## Visualization - Transitional Provisions according to ECE/TRANS/WP.29/GRVA/2020/28

# Transitional Provisions **new amendment**

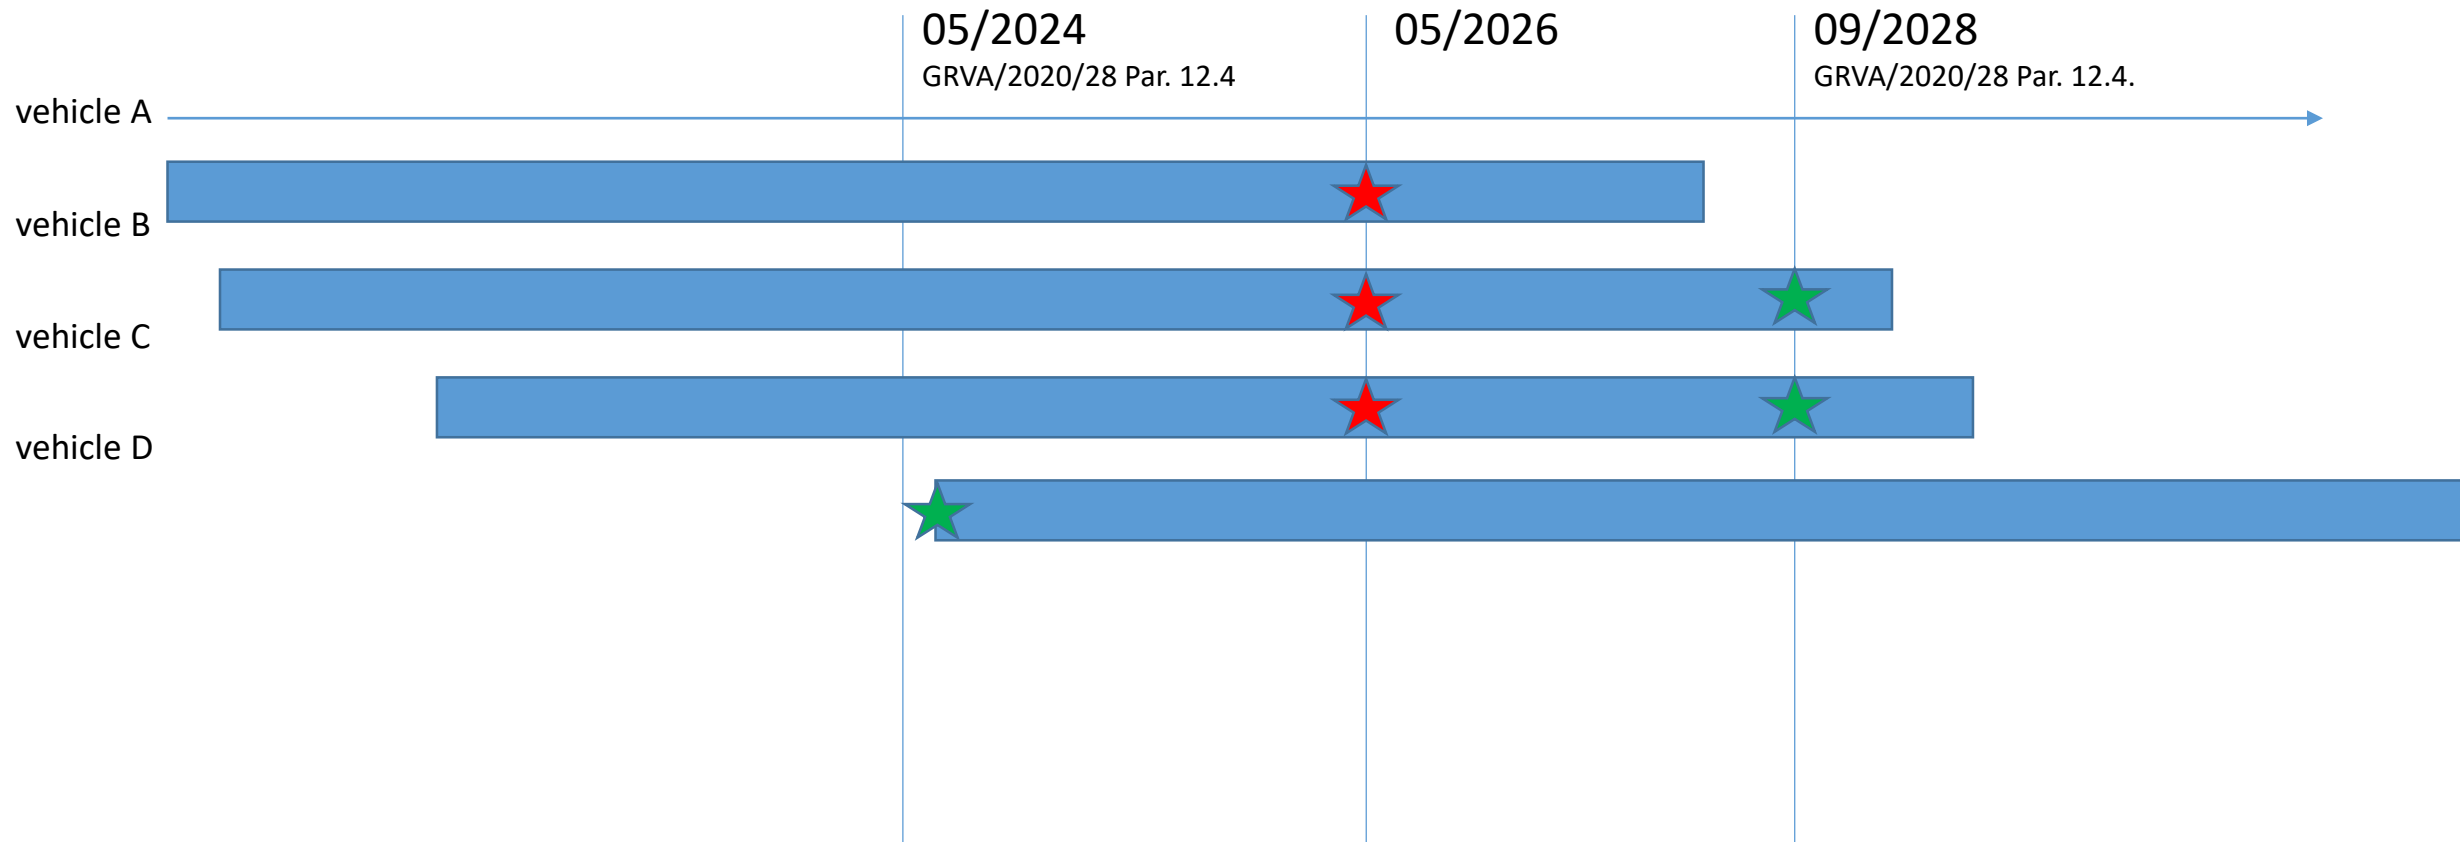
Must latest comply with C2B step 1

Must latest comply with C2B step 2

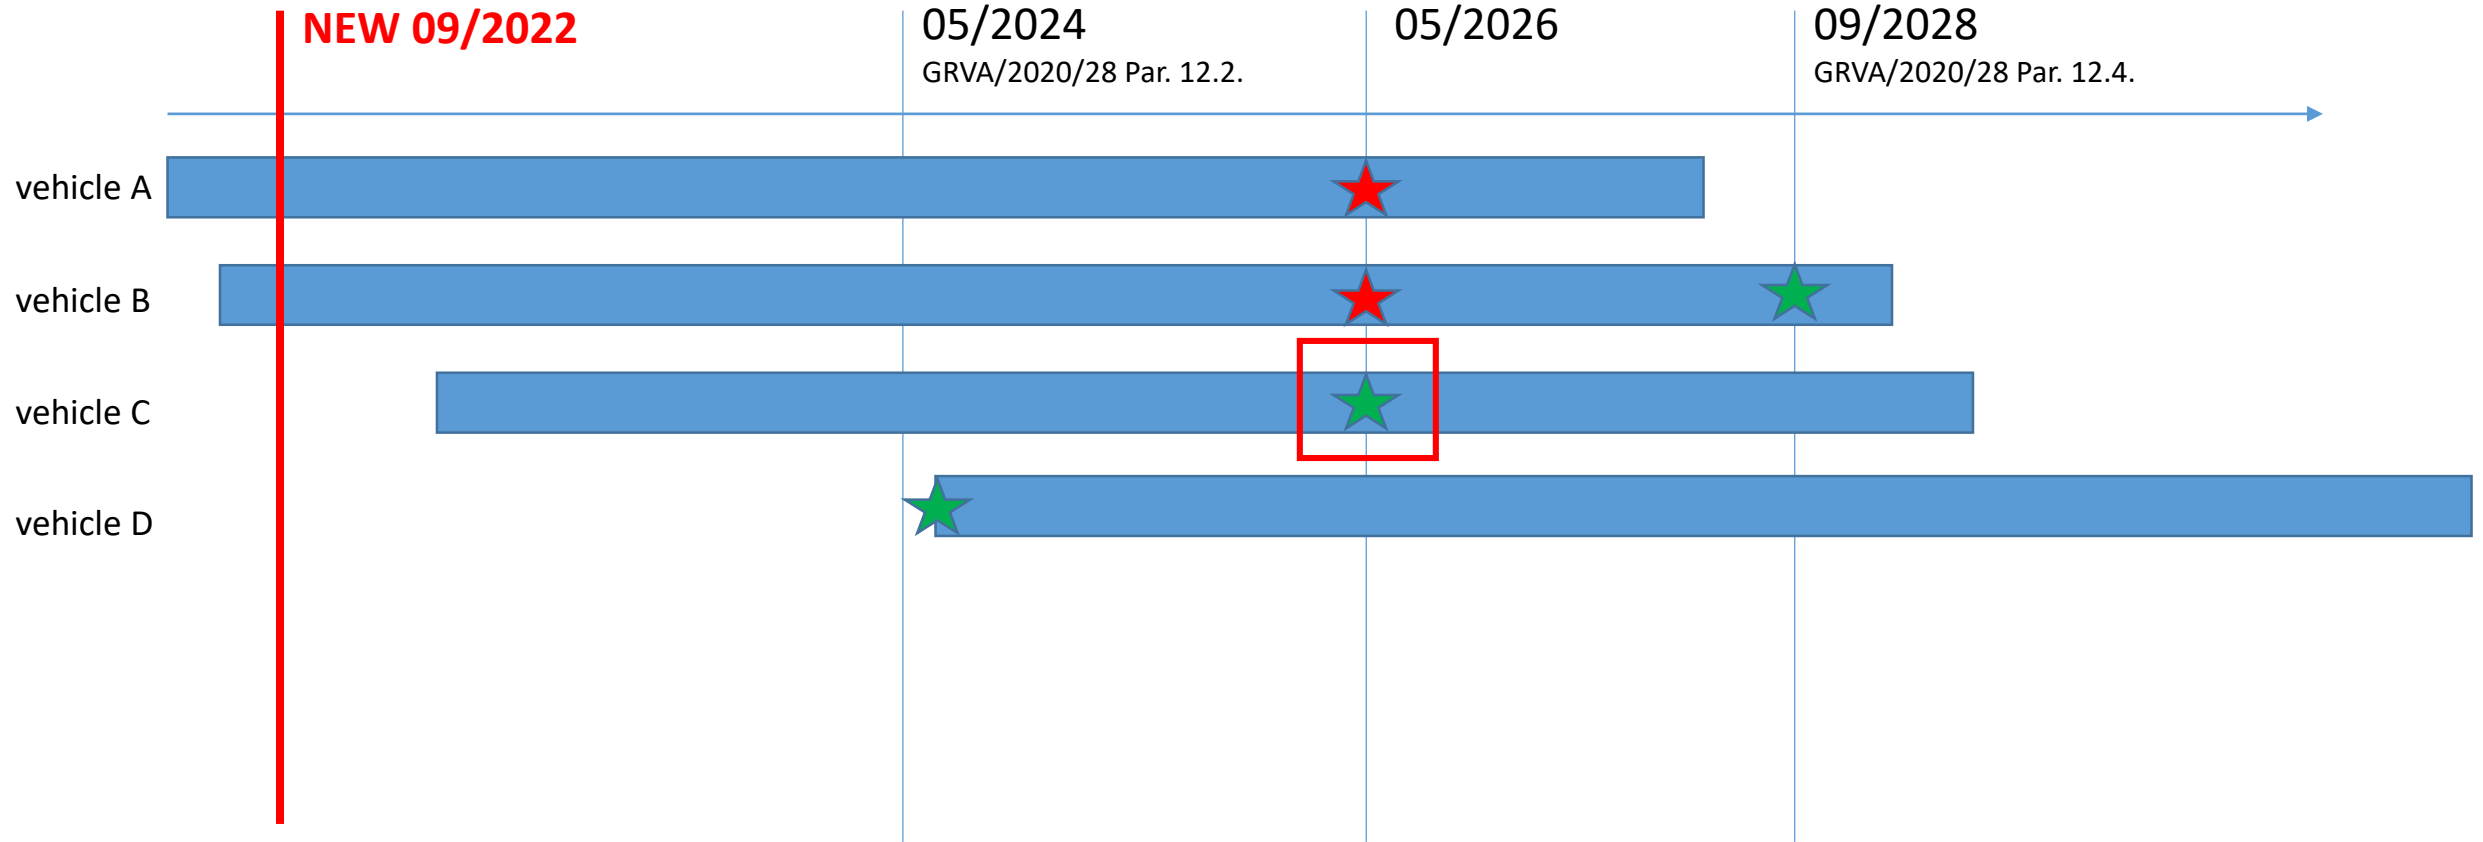
★ Must latest comply with C2B step 1

★ Must latest comply with C2B step 2

Renumber par. 12.2ff to be Transitional provisions of the 01 series of amendments

**12.2. Transitional provisions for the 02 series of amendments**

- 12.2.1.** As from the official date of entry into force of the 02 series of amendments, no Contracting Party applying this Regulation shall refuse to grant or refuse to accept type approvals under this Regulation as amended by the 02 series of amendments.

- 12.2.2.** As from 1 May 2024, Contracting Parties applying this Regulation shall not be obliged to accept type approvals to the preceding series of amendments of this Regulation, first issued after 1 May 2024.

- 12.2.3.** Until 1 May 2026, Contracting Parties applying this Regulation shall accept type approvals to the preceding series of this Regulation, first issued before 1 May 2024. **However, approvals granted to the preceding series of this Regulation first issued before 1 May 2024 shall be accepted by the Contracting Parties applying this regulation until 1 September 2028 for vehicles that were first approved to UN Regulation No. 13-H in its 01 series of amendments/ UN Regulation No. 13 in its 11 series of amendments before 1 September 2022.**

- 12.2.4.** As from 1 September 2028, Contracting Parties applying this Regulation shall not be obliged to accept type approvals issued to the preceding series of this Regulation.

- 12.2.5.** Notwithstanding paragraphs 12.2.2. and 12.2.4., Contracting Parties applying this Regulation shall continue to accept type approvals issued according to the preceding series of amendments to this Regulation, for vehicles which are not affected by the changes introduced by the 02 series of amendments (i.e. car-to-car and/or car-to-pedestrian approvals are not affected by this new 02 series).

- 12.2.6.** Contracting Parties applying this Regulation may grant type approvals according to any preceding series of amendments to this Regulation or extensions thereof.
